RE: ASSESSMENT MANAGER INFORMATION REQUEST (PLANNING ACT 2016 – SECTION 12 OF THE DEVELOPMENT ASSESSMENT RULES)

LOT 96 RP187418 – 54 GEORGE ALEXANDER WAY, COOMERA QLD 4209

- Development Permit – Reconfiguring a Lot of Subdivision (1 into 2 lots, new road, access easement and balance lot)
- Development Permit – Material Change of Use for Multiple Dwelling (208 units and 10 townhouses)

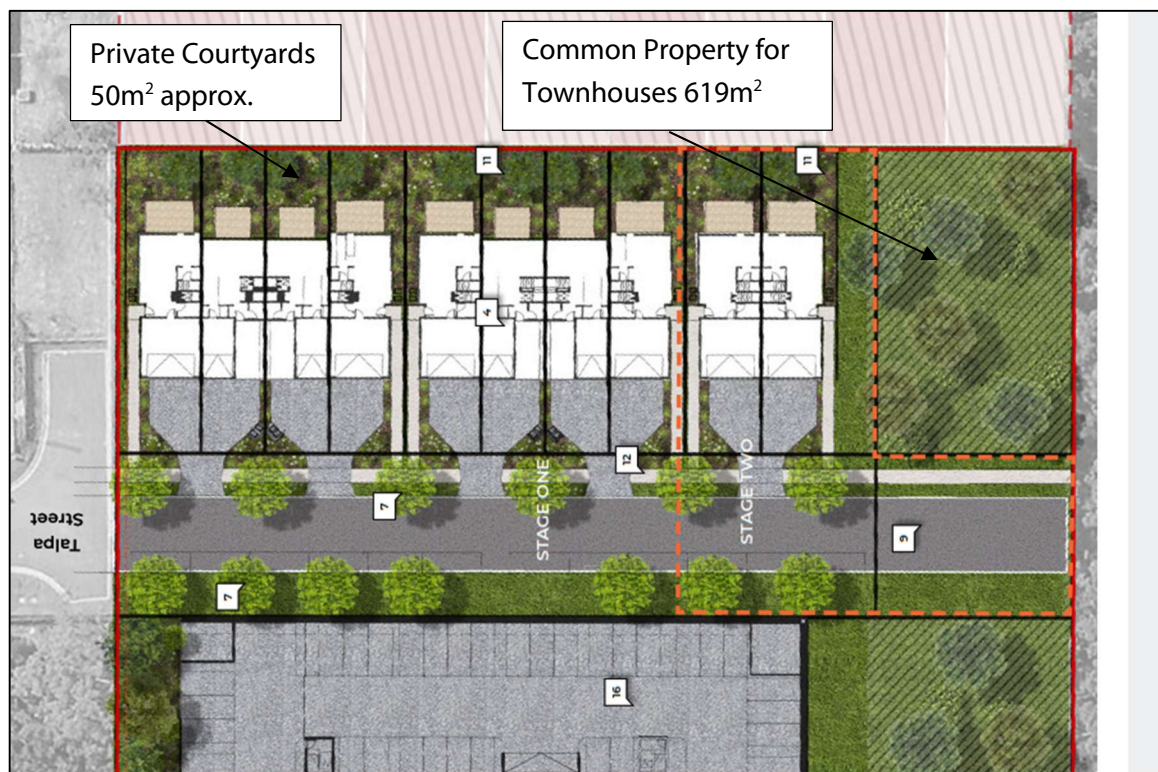
The submitted plan set shows insufficient information relating to the proposed townhouses to allow for appropriate assessment, specifically in relation to setbacks. As such, the applicant is requested to provide additional plans showing only the proposed town houses

with all relevant information outlined including setbacks, elevations and cross-section, and all area calculations.

The proposal plan set (**Attachment A**) has been amended to provide all required information for the townhouse product including setbacks, elevations and site cover.

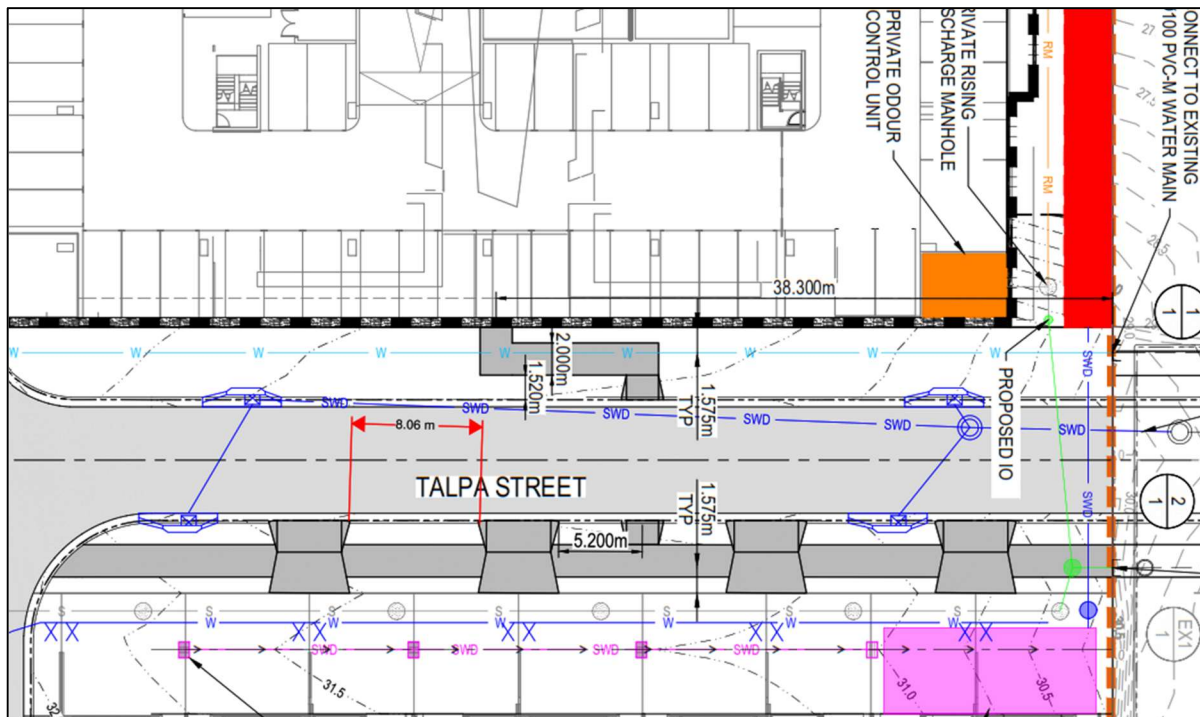
Demonstrate the vehicle crossings are appropriately separated to maintain on-street carparking spaces. Specifically, the applicant is required to provide the distance between each of the townhouse vehicle crossings. Please ensure this is a minimum of 7.0m separation at the kerb line in order to ensure there is an on-street carpark between the vehicle crossings.
